Application No. 08-0080

**Site Plan**

Showing Existing & Proposed Conditions

Site Info: Pole # 56, Wallum Lake Road  
Pascoag, R.I.

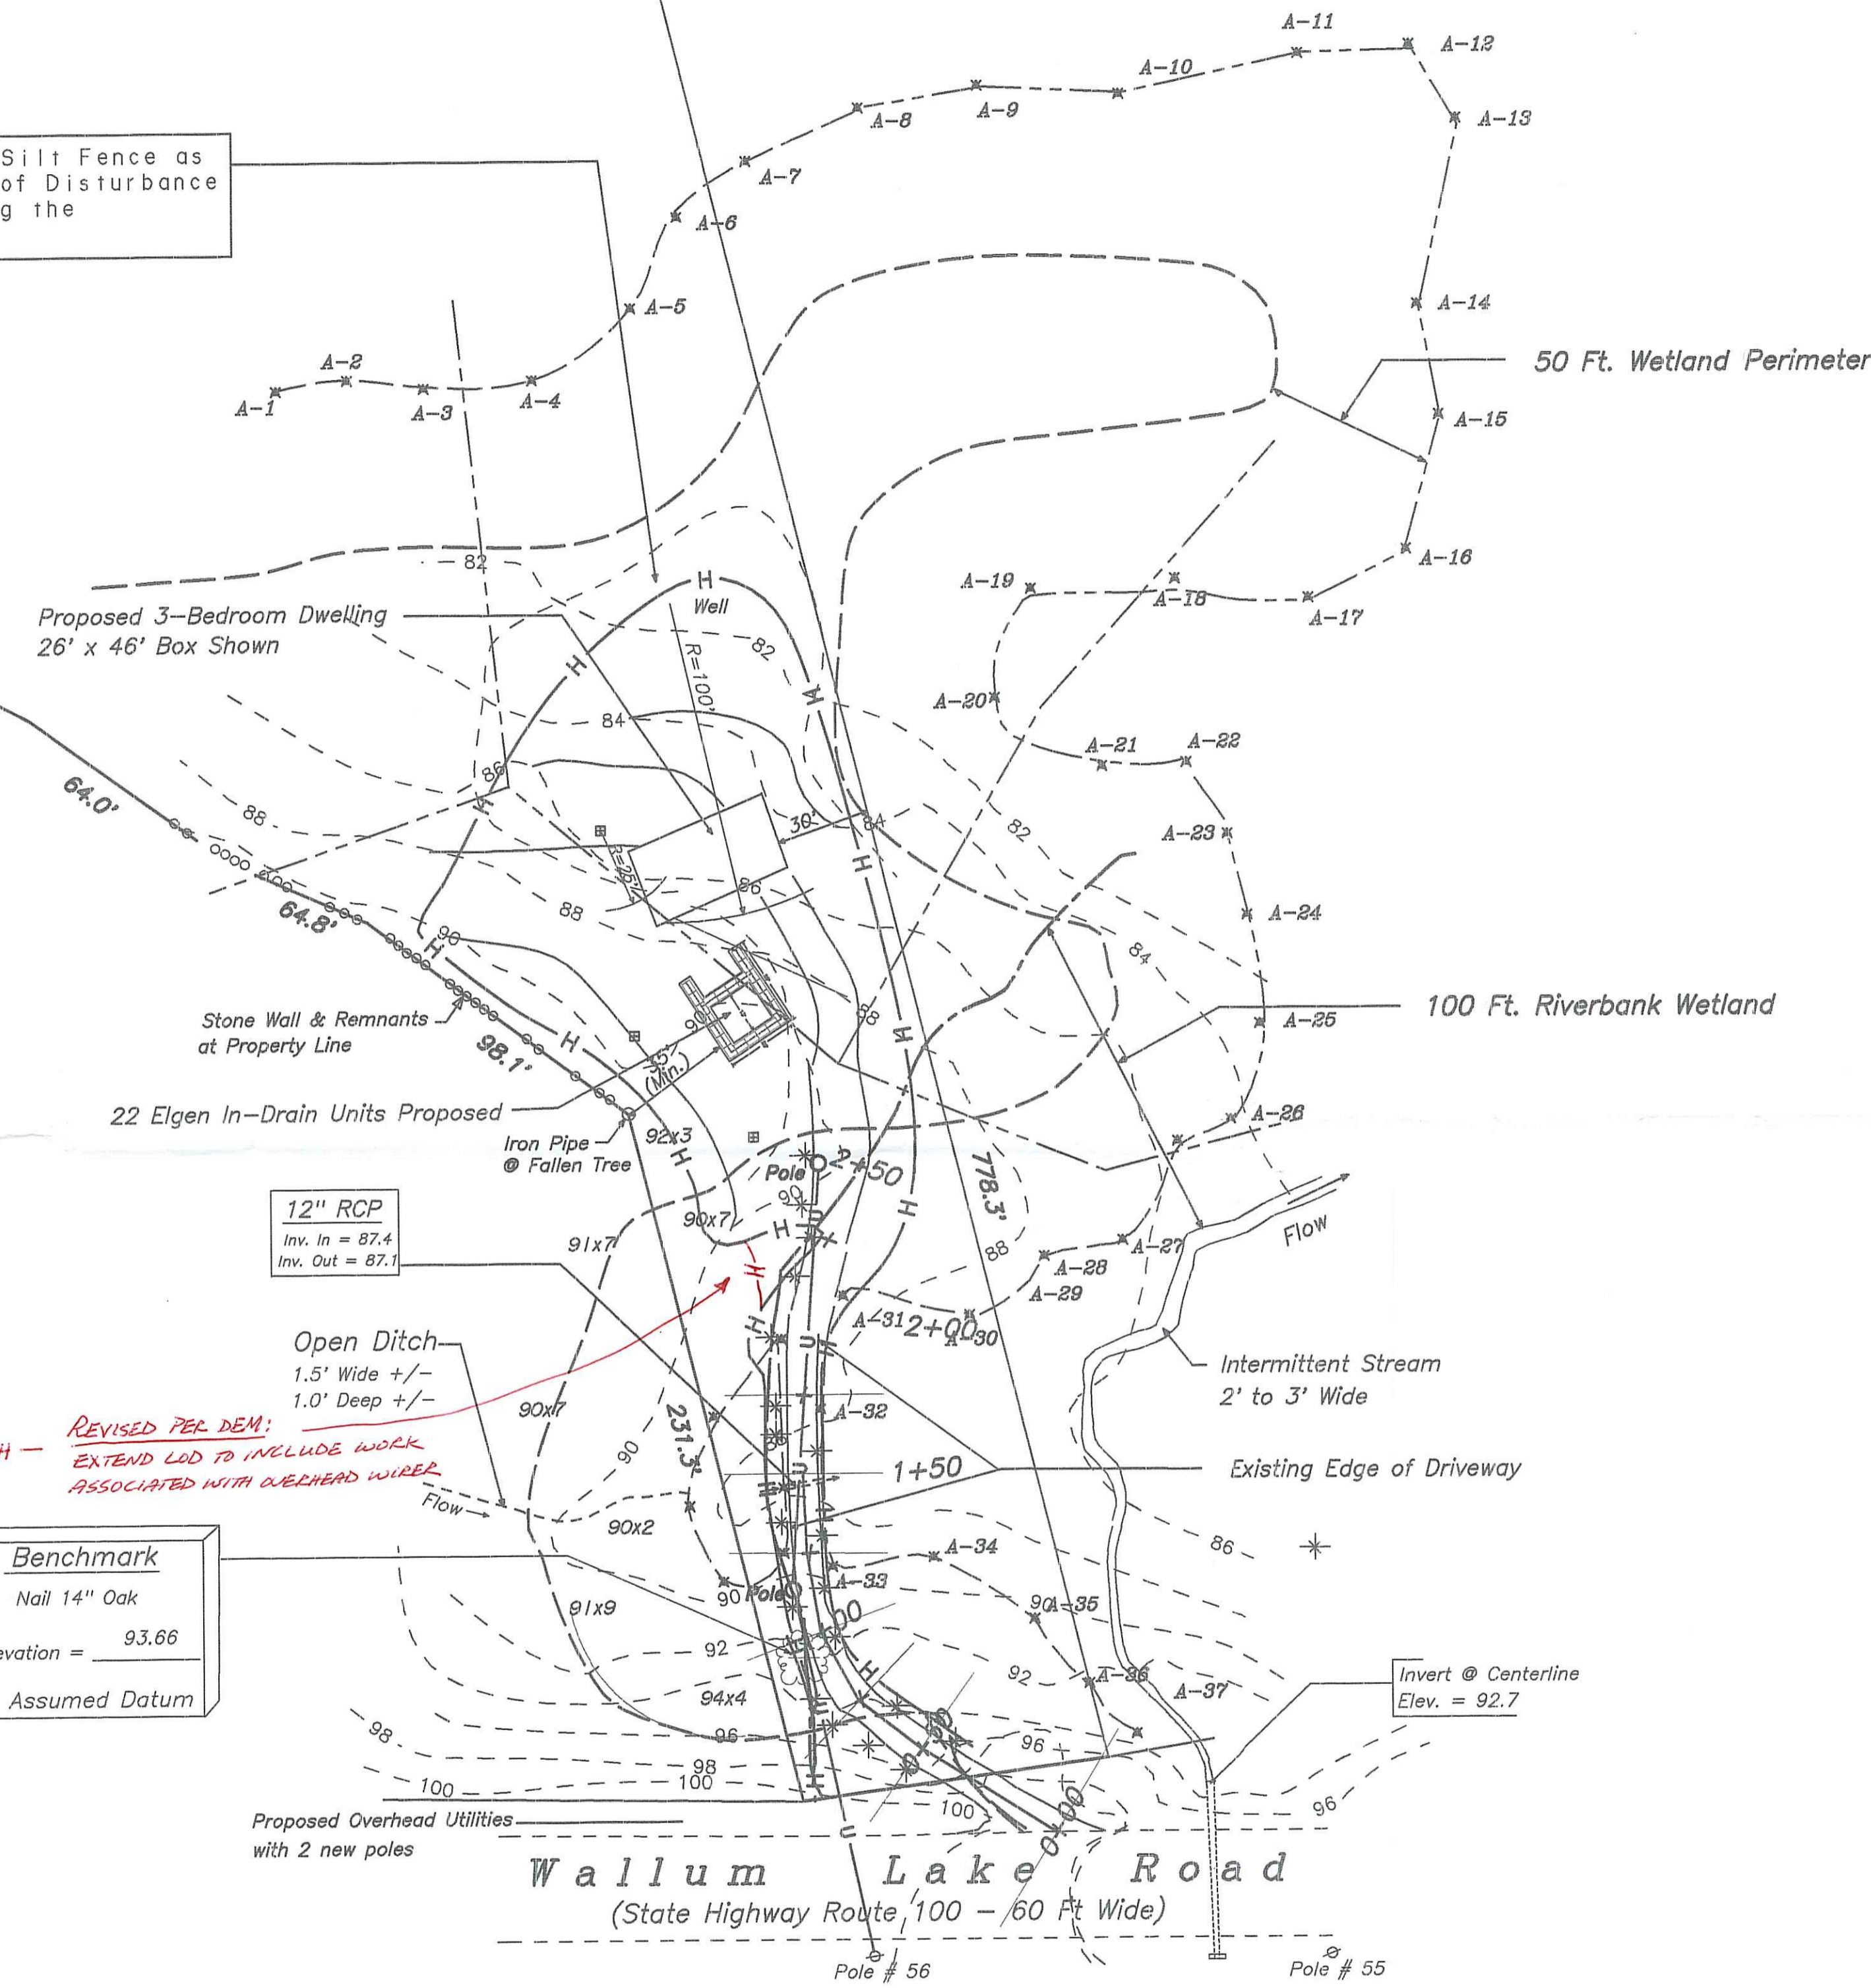
REVISD PER DEM:  
EXTEND LOD TO INCLUDE WORK ASSOCIATED WITH OVERHEAD WIRE

Revised 7/09/08 ... Added Sheet 2  
Revised 5/12/08 ... Pole moved inside LOD  
Revised 5/10/08 ... per Biological Review Sheet & Grading Note
